WOLLONGONG CITY COUNCIL

Local Transport Forum Minutes

9 June 2026

Item 2.1 - COLEDALE, Lawrence Hargrave Drive – Coledale Village Centre Parking Changes

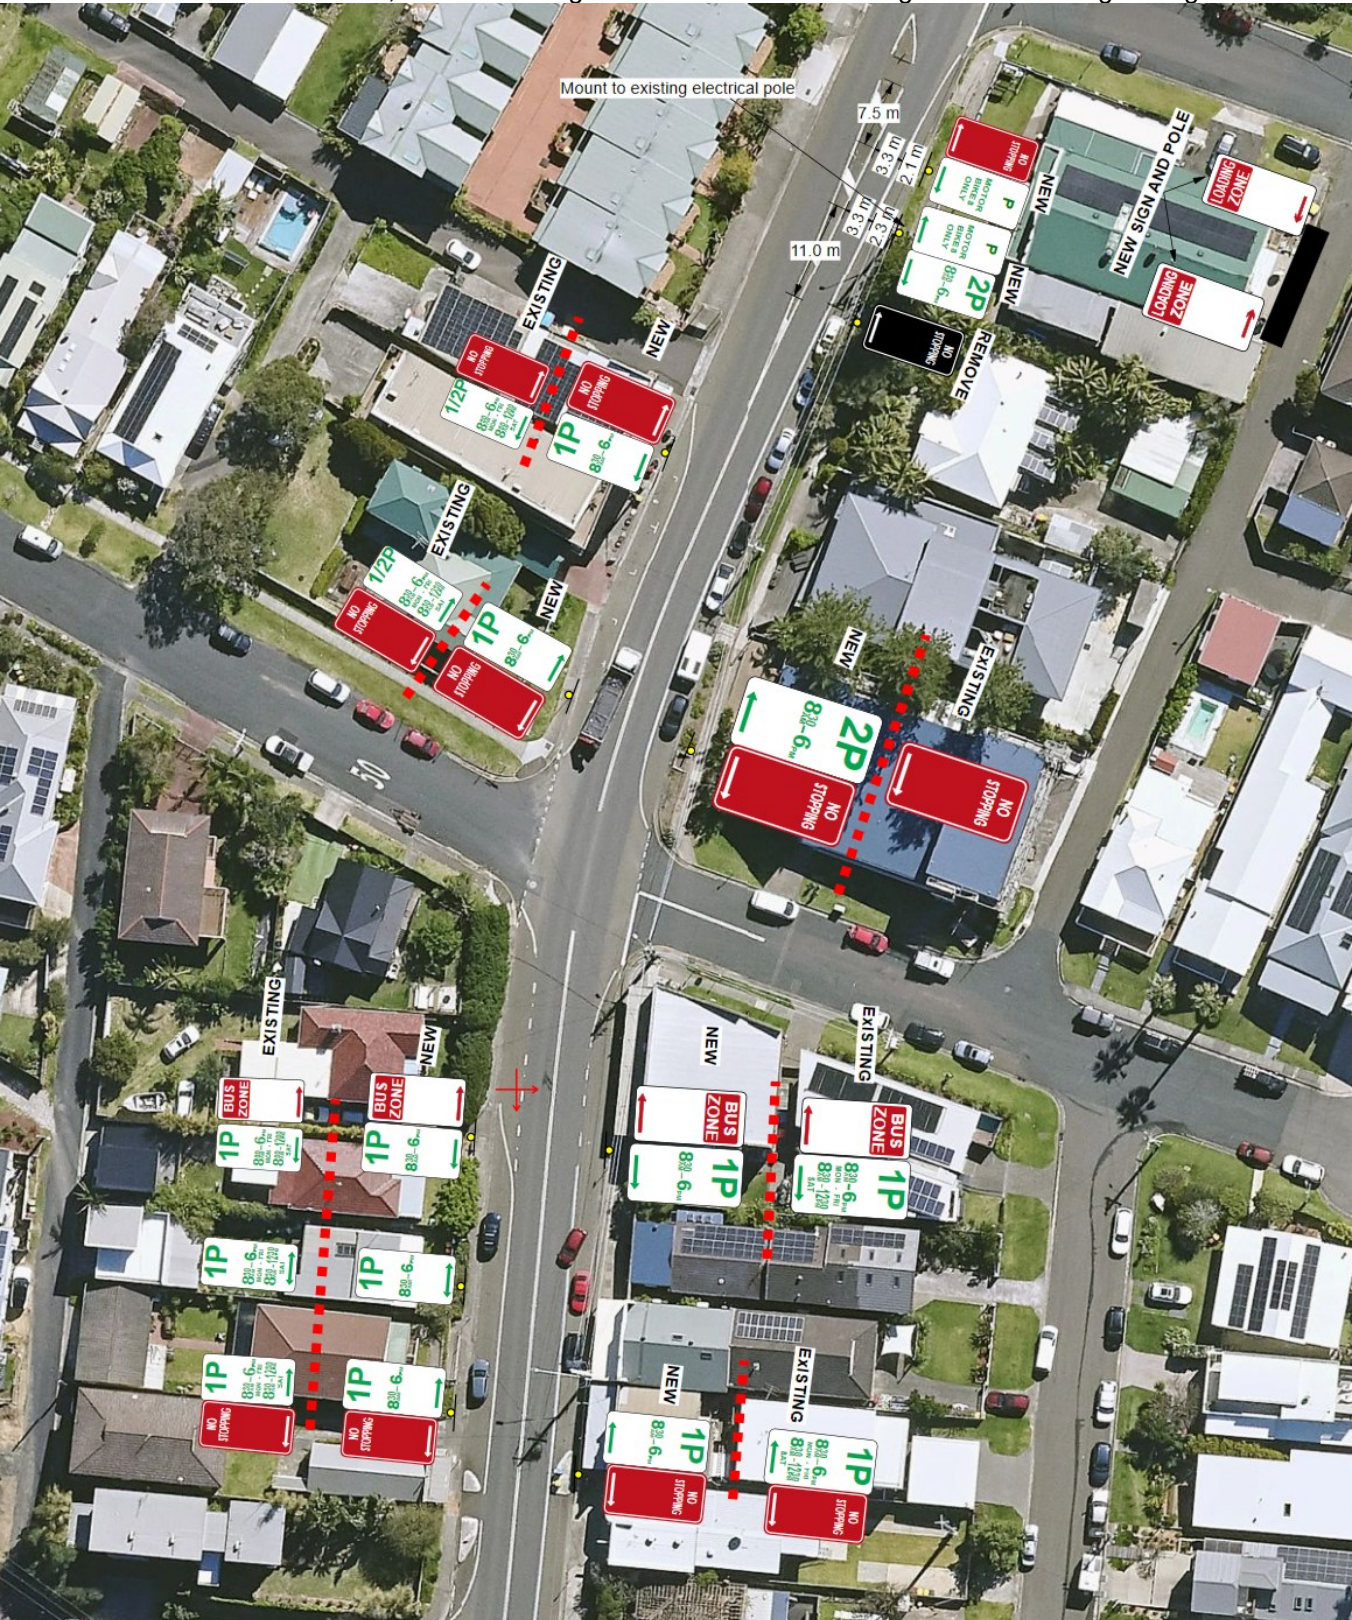
Changes to the no-stopping distance and parking restrictions on the southbound departure side of the refuge crossing on Lawrence Hargrave Drive, fronting the Coledale RSL were sent to TfNSW. This is to seek advice on whether approximately 18m of no-stopping space can be converted to motorcycle-only or 2-hour (2P) parking. No response has been received at the time of writing the report. Council has submitted to Local Transport Forum for TfNSW to review and provide advice on this proposed change.

Forum Member /Guest	Advice	Council Comment
TfNSW	The following advice is in relation to the proposed changes to the No Stopping zone near the refuge on Lawrence Hargrave Drive (south of Cater Street). All other changes proposed have no objections or comment. AS 1742.10 and the Transport for NSW supplement are the primary technical references for pedestrian refuges. Any departure from the No Stopping requirements must be supported by a concession to standard.	Council notes the supplement and TfNSW advice. Conditions 1 & 2 have been added to the proposal.

The attached plan be approved subject to:

1. The removal of the proposed motorcycle parking
2. Concurrence from Transport for NSW to a concession to standard to permit the proposed 11m extension of 2P parking. Should concurrence not be received, No Stopping zone to remain.

Item 3.2 – CORRIMAL, Harbinger Street – Corrimal Coke Works - S138 Roundabout next stage installation

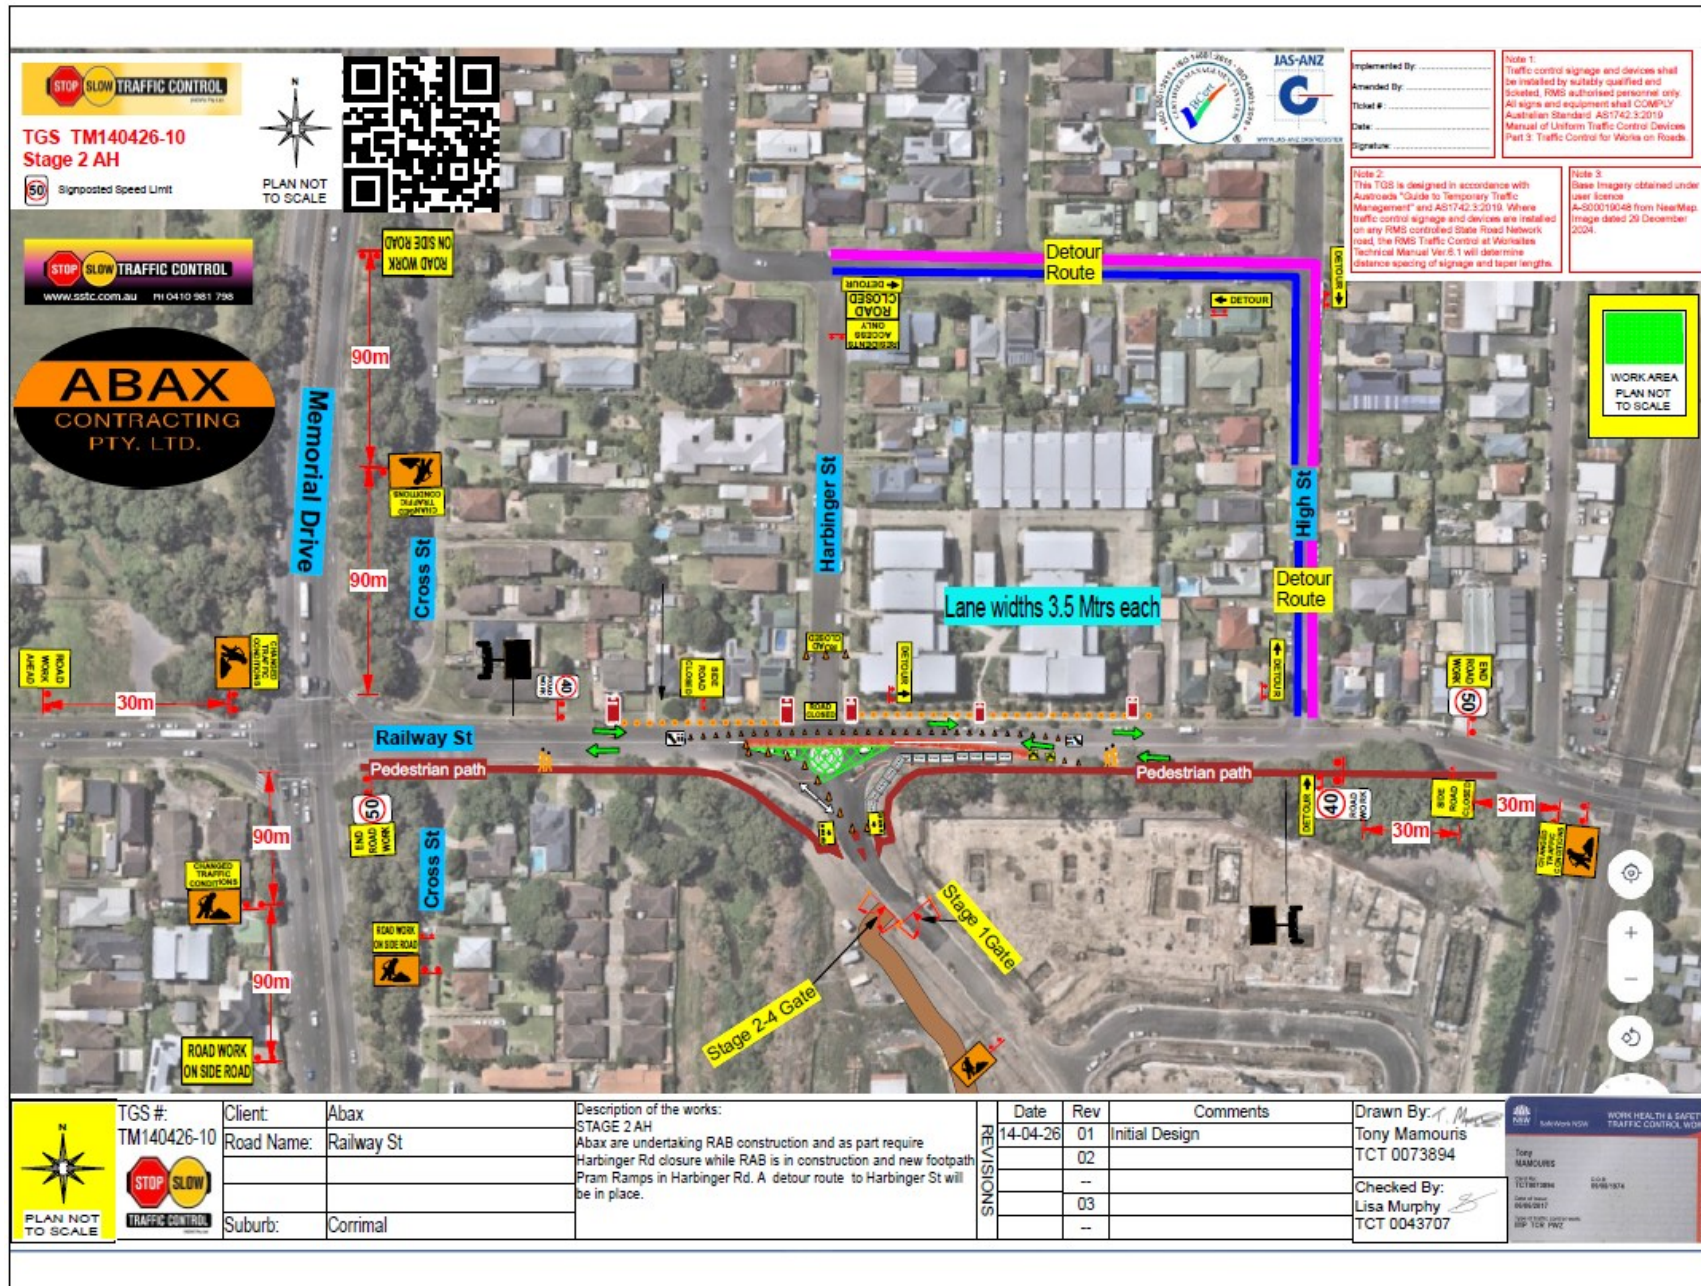
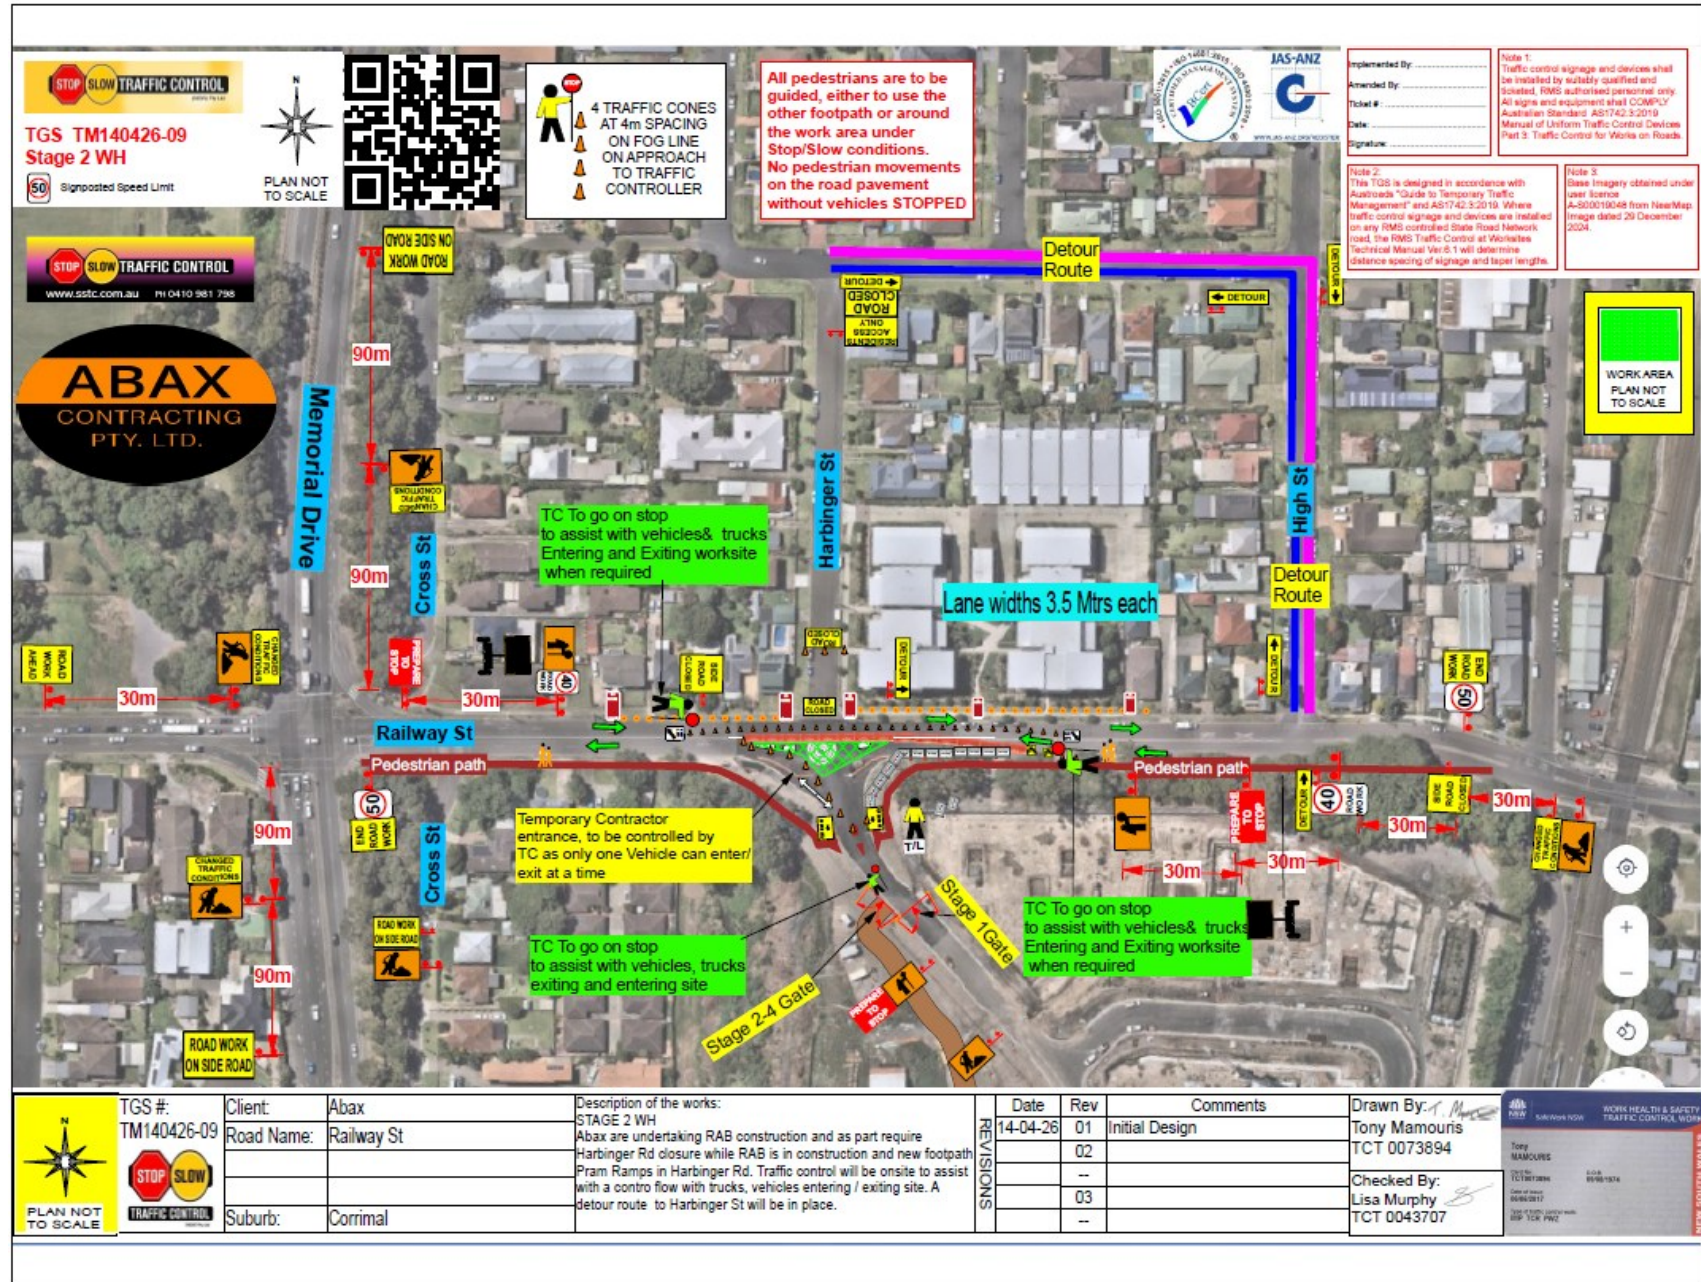
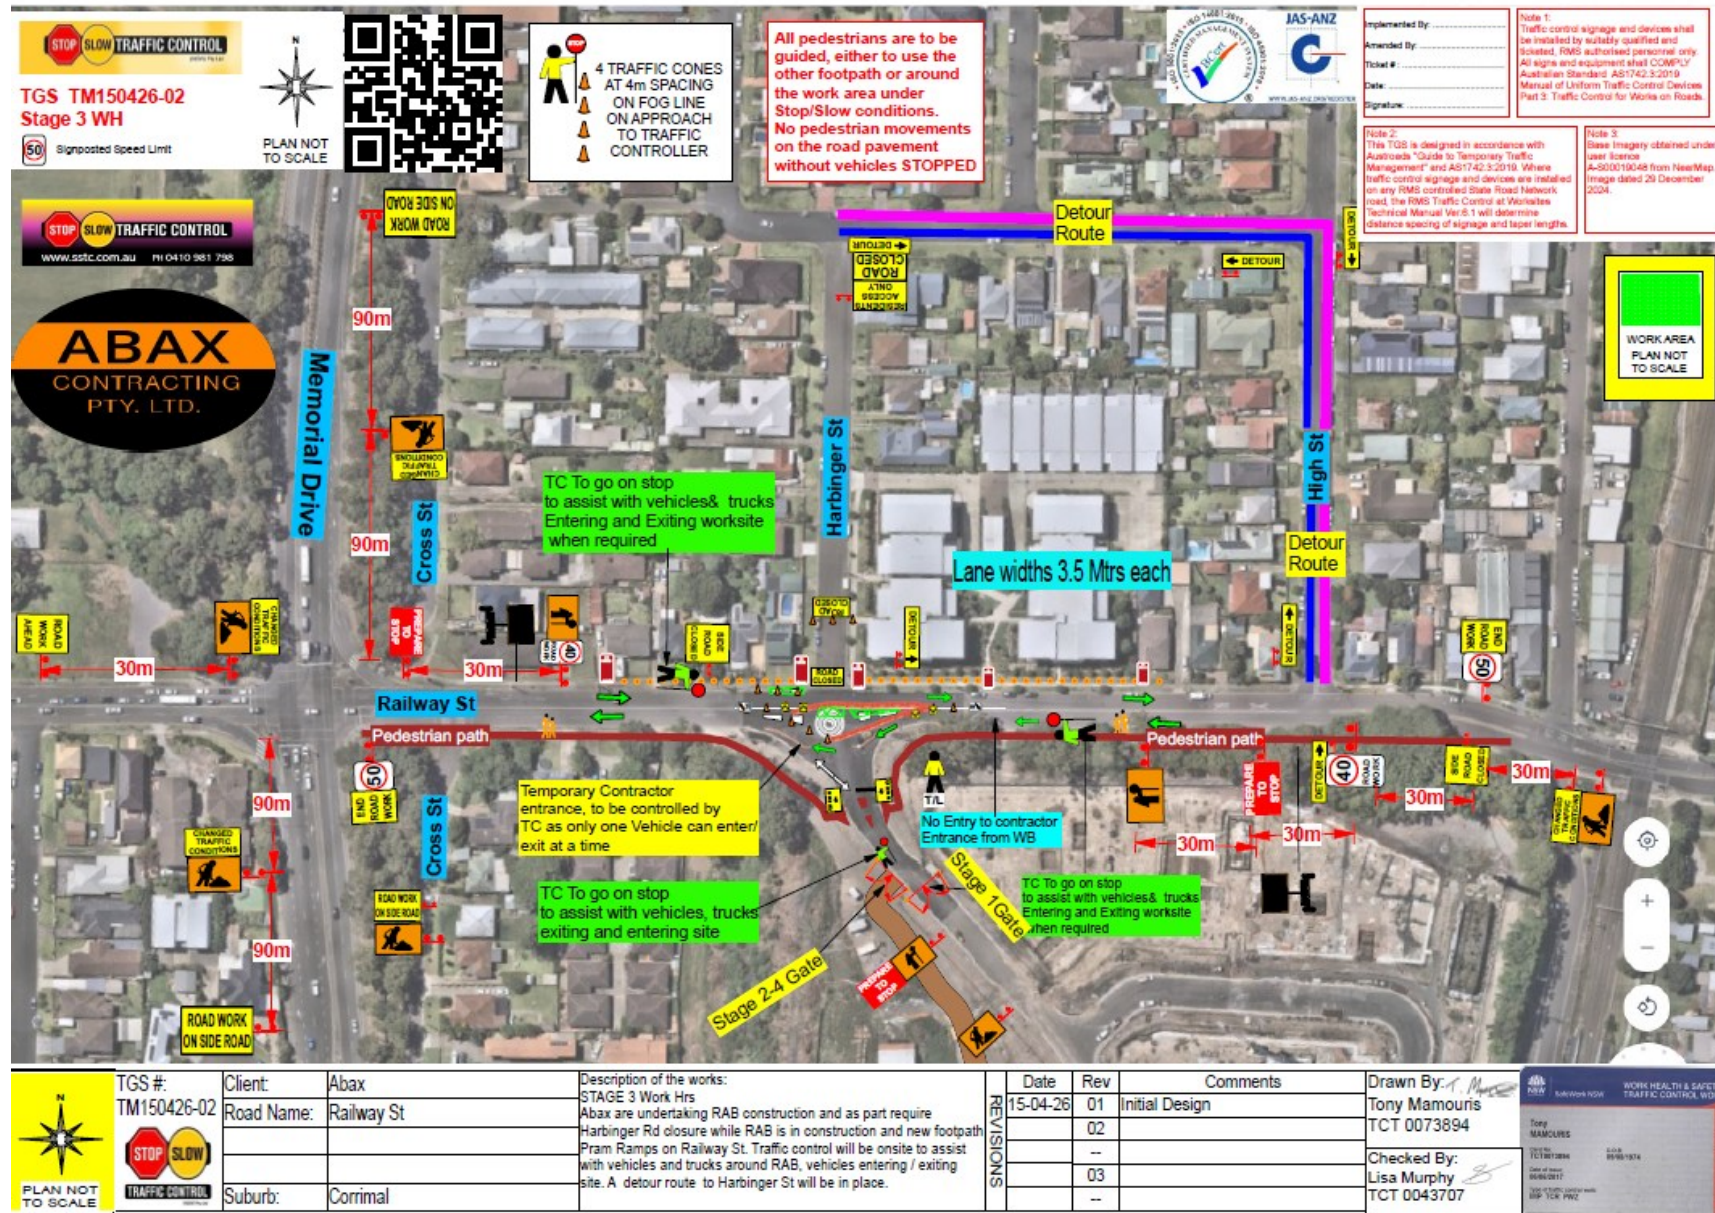
Forum Member/Guest	Advice	Council Comment
Premier Illawarra	A Bus Zone exists on Railway Street., Corrimal. Further consultation with Dion's Bus Services will be required in terms of impacts.	Condition #4 revised to reinforce the need for bus operator concurrence.

The proposed road closures be approved subject to:

1. [Council's Standard Conditions for Road Closures.](#)
2. Section 138 approval from Council
3. Variable Message Signs (VMS) signs to be installed (retained) in both directions for the duration of the works.

4. Consultation with Transport for NSW regarding the need for extensions and/or approvals for Road Occupancy Licenses and management of impacts to the State Rail (Railway Street level crossing queuing), State Transport Network (Memorial Drive queuing) and bus service impacts. Bus Zones exist on Railway Street which are impacted by the proposal. Bus Operator concurrence (particularly with Dion's Bus Services) must be obtained prior to the closure. Applicant must provide Council with evidence that bus services have been accommodated to the relevant bus service's satisfaction prior to works.

5. Letterbox drop notification to impacted residents taking place at least two weeks prior to the road closure. This is to include all properties who use Harbinger Street, High Street and Ruddock Street for access and egress to Railway Street (and subsequently may have their journeys directly impacted by the closure)
